**ADDENDUM #4**

**IFB 16-04 VIENNA COMMUNITY CENTER RENOVATIONS AND EXPANSION**

**ADDENDUM NO. 4**

**VIENNA COMMUNITY CENTER  
RENOVATION AND EXPANSION  
IFB16 – 04**

**NEW WORK - UPPER LEVEL AND CLERESTORY MECHANICAL FLOOR PLAN**  
SCALE: 1/8"=1'-0"

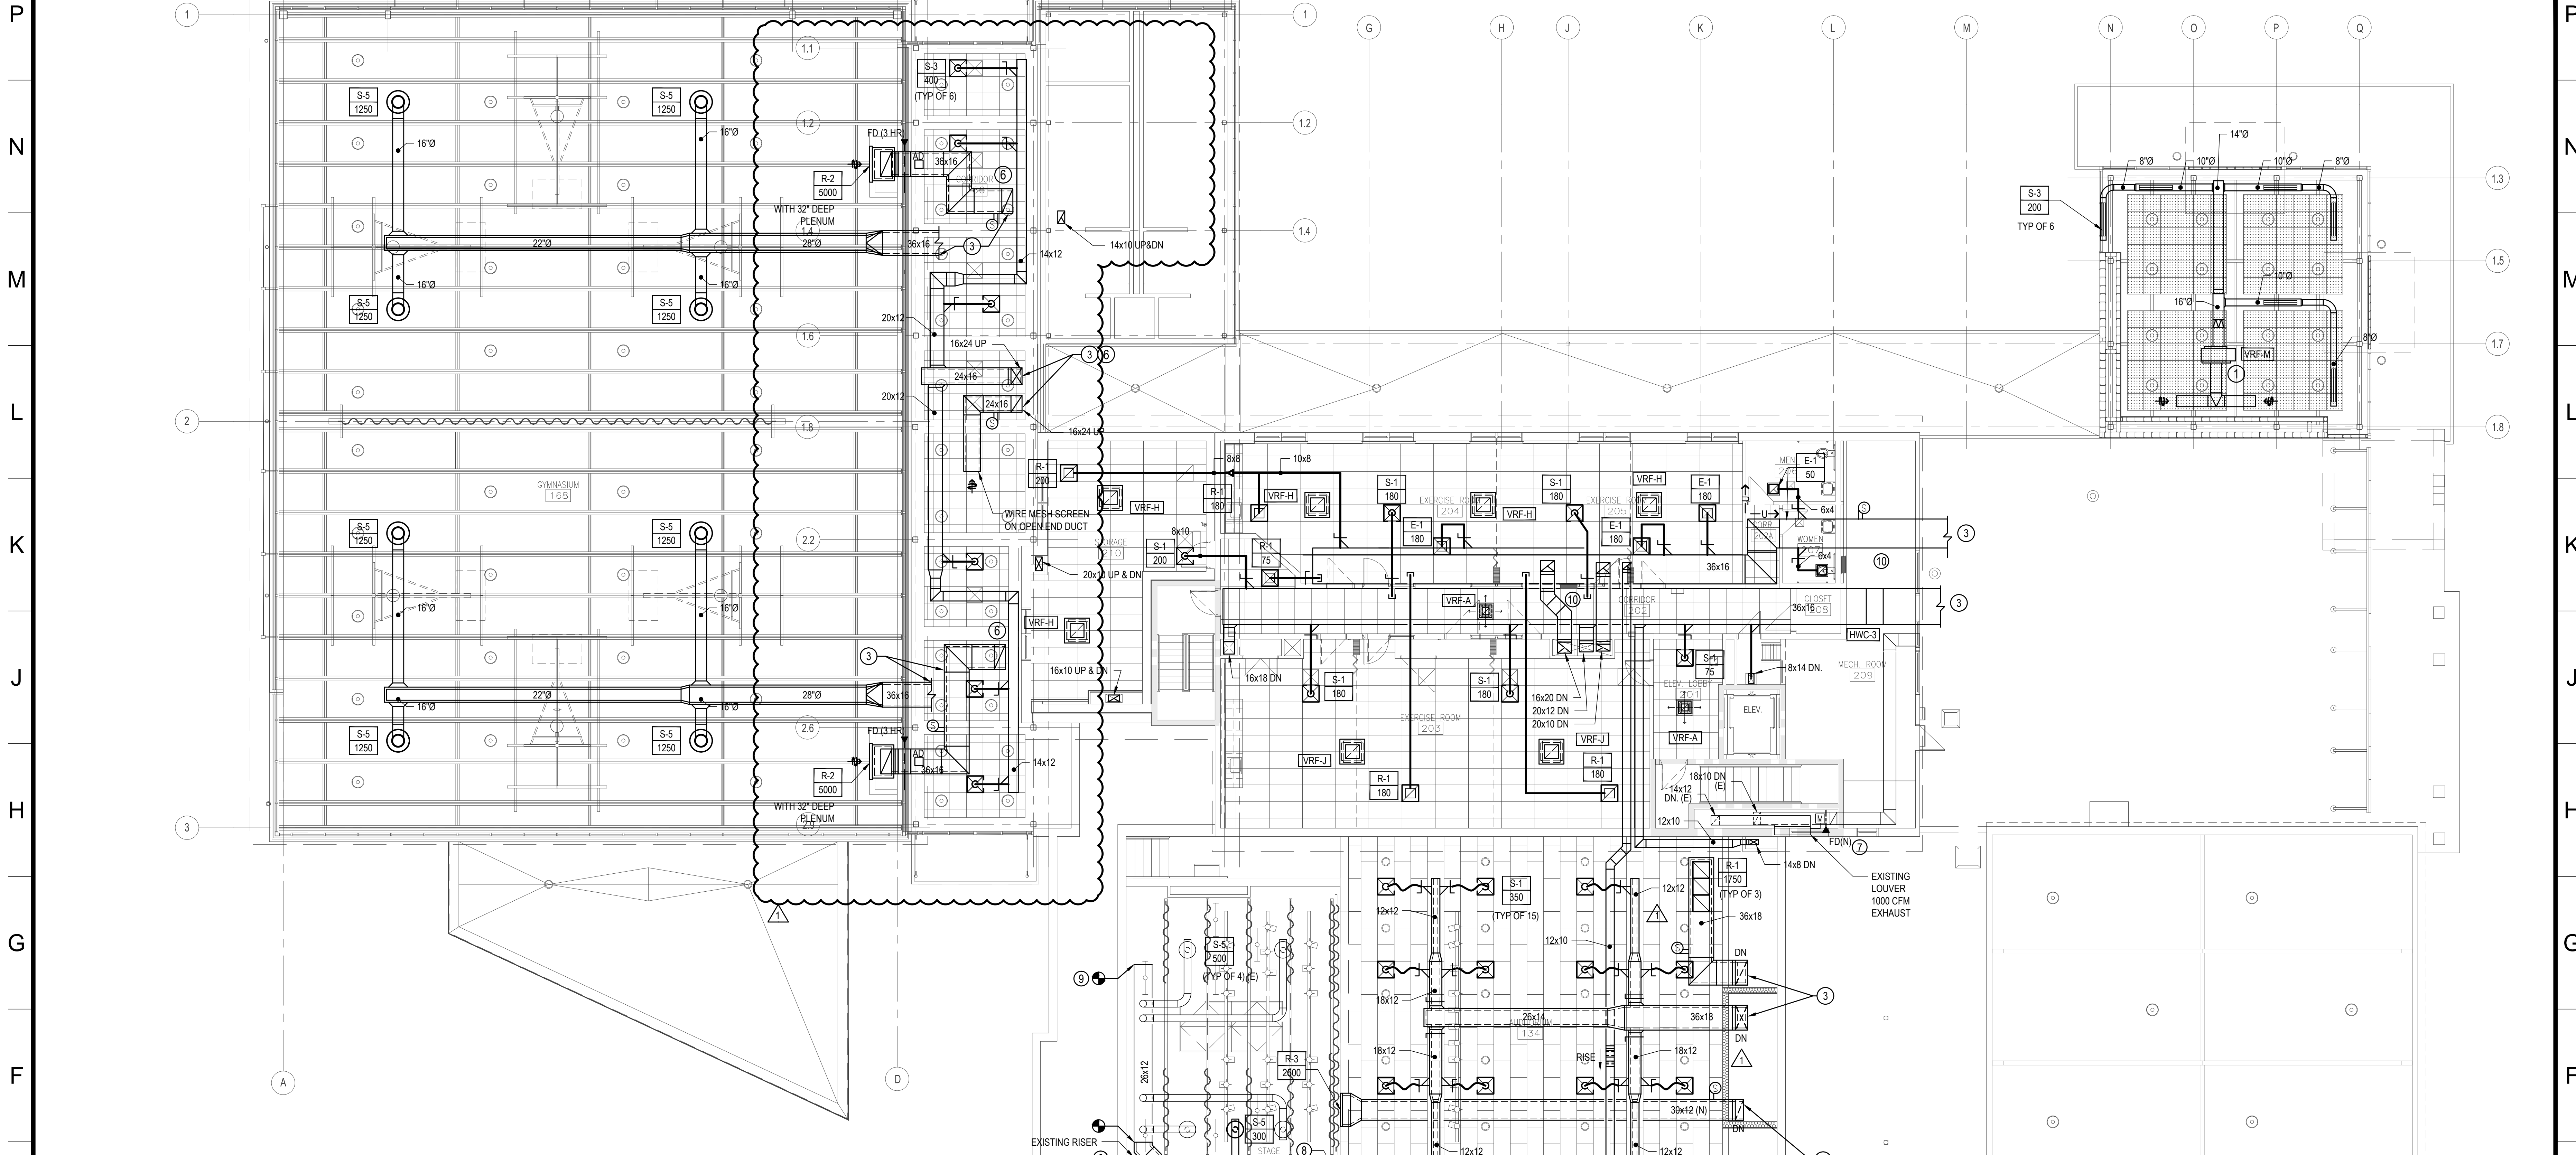
<b>DOCUMENT</b>	<b>DESCRIPTION</b>
3.00	IFB16-04	The due Date and Time for submission of BID remains unchanged by ADDENDUM NO. 4
	<b>DRAWINGS</b>	The following Clarification is being issued.
3.04	M102, UPPER LEVEL AND CLERESTORY FLOOR PLAN	<b>DELETE:</b> Both Drawings of M102 NEW WORK - UPPER LEVEL AND CLERESTORY FLOOR PLAN issued with ADDENDUM NO. 2  <b>ADD:</b> M102 NEW WORK – UPPER LEVEL AND CLERESTORY PLAN. This is the same plan issued with ADDENDUM NO. 2 but is being sent for clarity between the two M102 Drawings files.
